Glen Canyon Powerplant Upgrading

## Finding of No Significant Impact

FINAL  
ENVIRONMENTAL ASSESSMENT  
FOR  
GLEN CANYON POWERPLANT UPRATING

# FIGURE 3

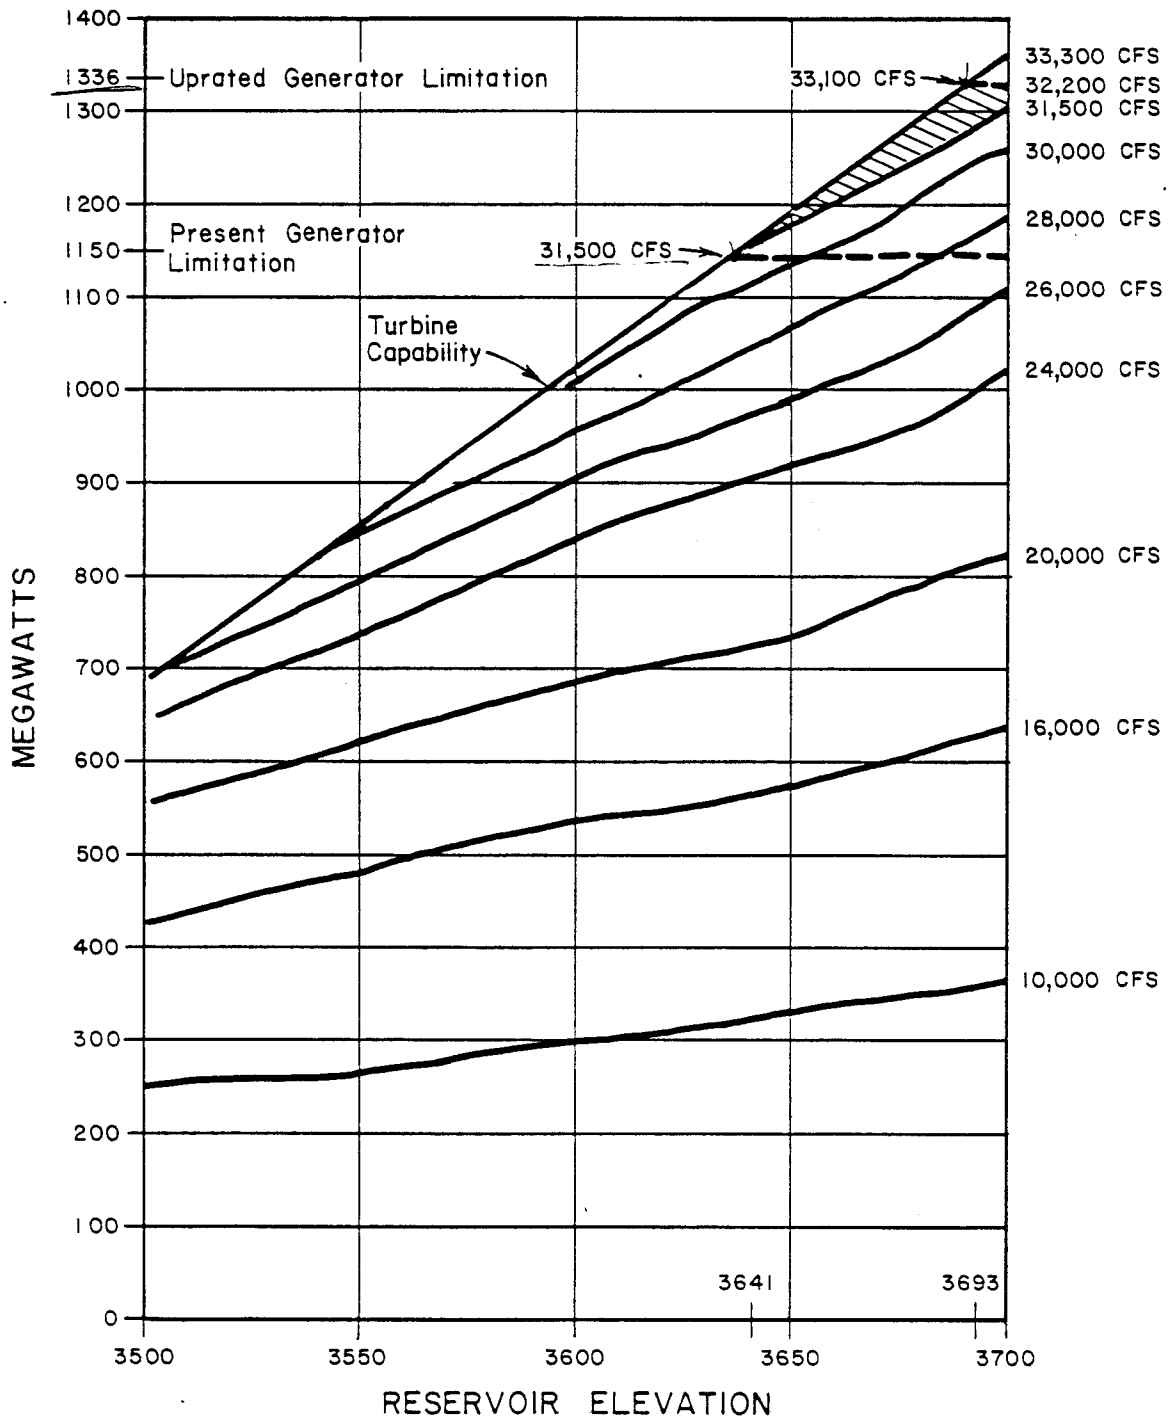
COMMENT: Explain the values for Figure 2.

COMMENT: Figure 3 - If higher maximum releases are to be compensated for by lowering mid-range releases, discuss the effect of these considerably larger daily variations.

COMMENT: If Figure 1 is correct, uprating will raise the maximum power outflow from 27,000 cfs to 33,100 cfs, a much more significant increase of 6,100 cfs than the 1,600 cfs the text asks us to accept.

RESPONSE: Figure 2 has been changed to Figure 4 in the final environmental assessment. This figure shows the future probability of Lake Powell reservoir elevations through year 2040. The data boundary line represents the statistical lower limit of reservoir elevation and the probability lines show the probability of the end of water year elevation being between a certain probability line and the data boundary for any given year. For example, at the end of water year 2000, there is a 25 percent probability that Lake Powell's elevation would be between 3620 feet and 3655 feet and a 75 percent probability that it would be between 3655 feet and 3700 feet.

RESPONSE: The higher maximum releases and the lower mid-range releases would probably not occur on the same days. When power demand is high during the peak hours of a given day, it is also usually relatively higher during non-peak hours of that same day than on days when peak demand is not so high. This tends to keep the range of fluctuation comparable. In any case, impacts from larger daily variations would be negligible below Lees Ferry due to the dampening effect of the river. Section III. under River Environment and River Mechanics discusses this effect.

RESPONSE: Figure 1 has been changed to Figure 3 in the final assessment. Data from the curves shown on Figure 3 have been summarized in Tables 2 and 3 and are described in Section II.B.2.
